SERVICE INFORMATION LETTER

SERVICE INFORMATION LETTER INDEX

FIGURE 1

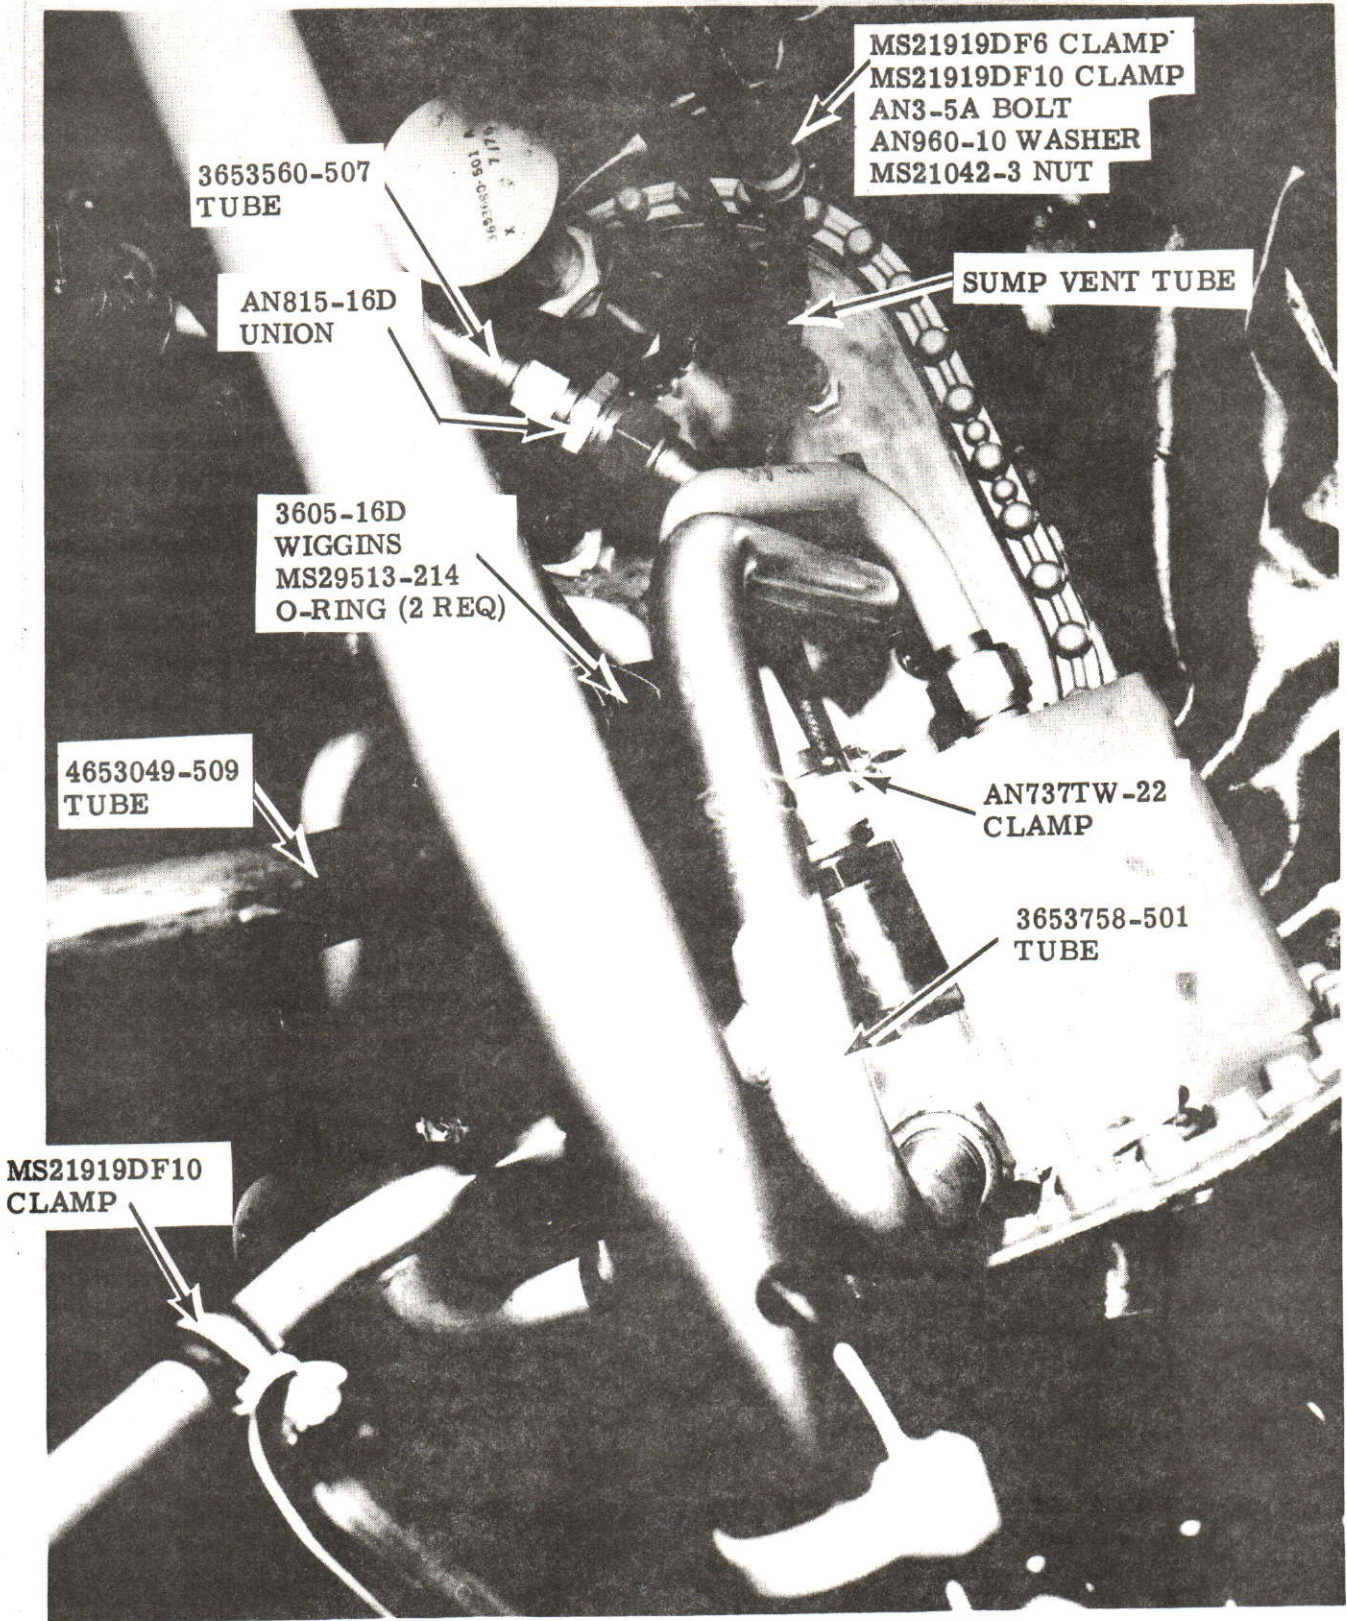
2. Assemble and install the fuel sumps as follows: (Refer to Figure 1).
- A. Install a 3653741-1 tube in each lower sump casing P/N 5653722-1-51 and 5653722-2-51 using a 4653743-505 gasket between tube flange and sump casing.

6. Refer to Figure 1 and install the boost pumps as follows:

RH FUEL SUMP
FIGURE 1B

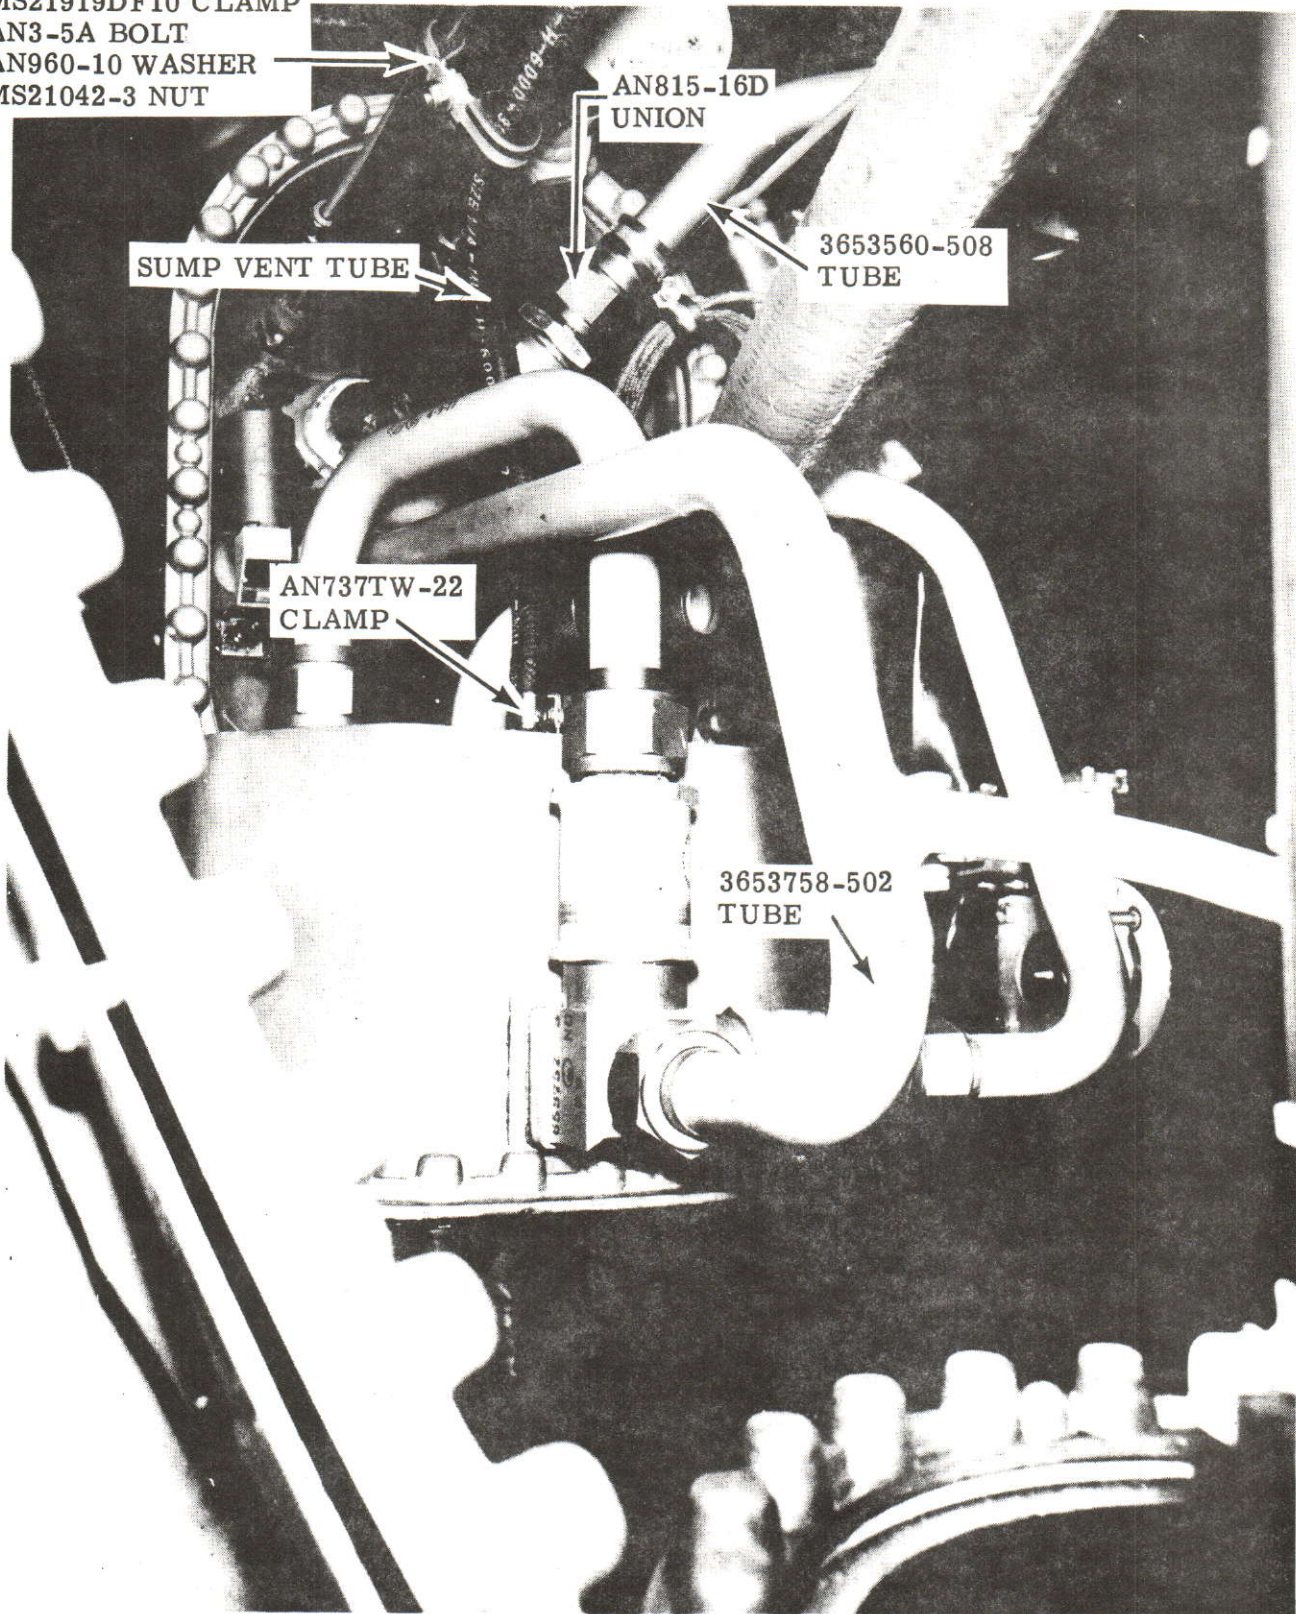
- F. Install sump to aircraft structure support bolts P/N AN4-5A and secure using AN960-416 washers and MS21042-4 nuts, (4 places on each sump).
3. Assemble and install sump check valves and tubing. (Refer to Figure 1, 1A and 1B).

FIGURE 2 MODIFICATION TO -503 EMERGENCY HYDRAULIC PUMP

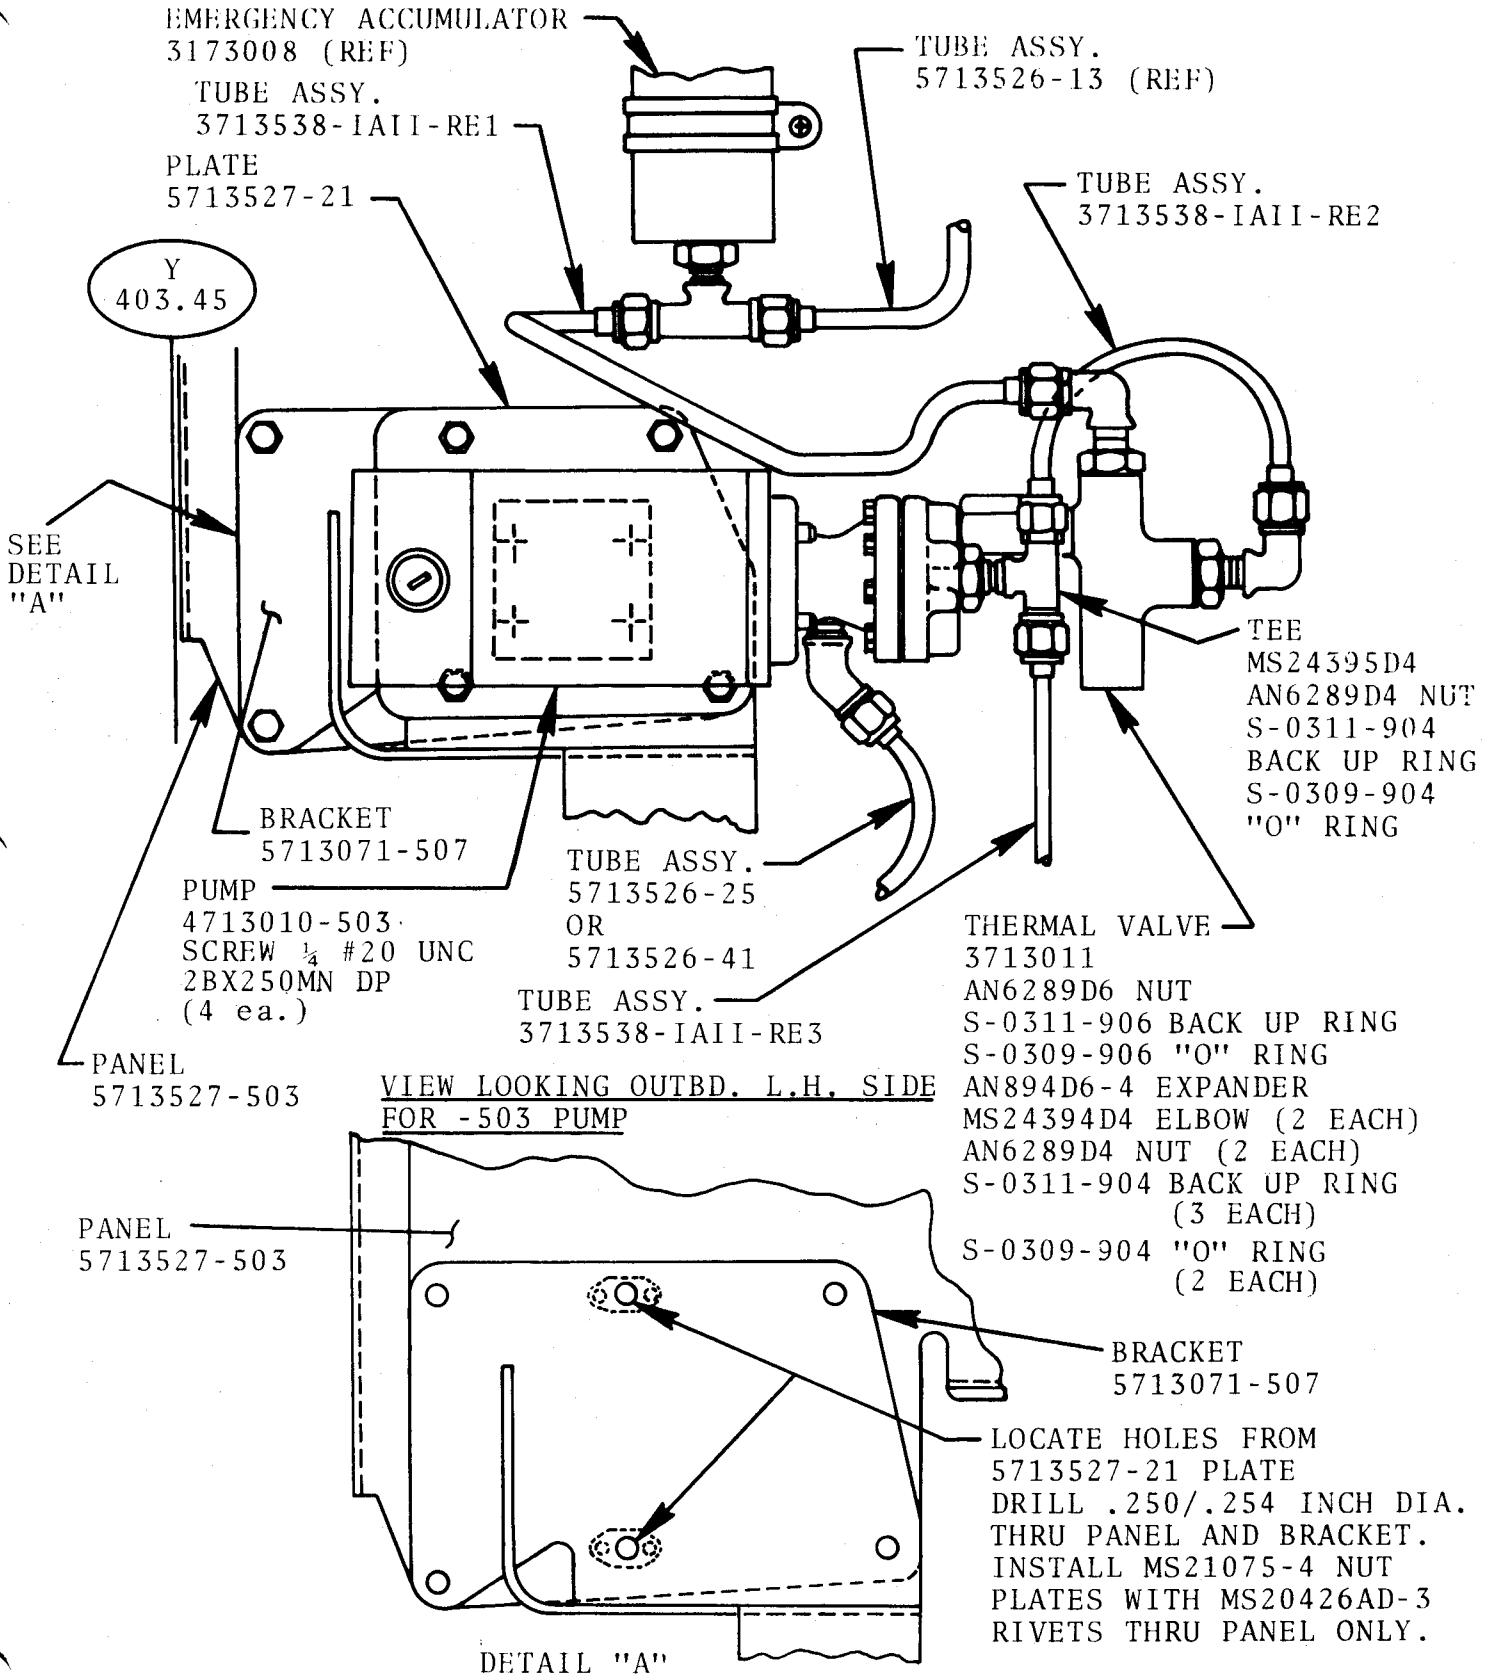
DELETE	ADD	
QTY	PART NUMBER	PART NUMBER	DESCRIPTION
1	3713538-IAII-RE1	3713538-69	Tube Assy.
1	3713538-IAII-RE2	3713538-71	Tube Assy.
1	3713538-IAII-RE3	3713538-75	Tube Assy.
1	- - - - -	3713538-73	Tube Assy.
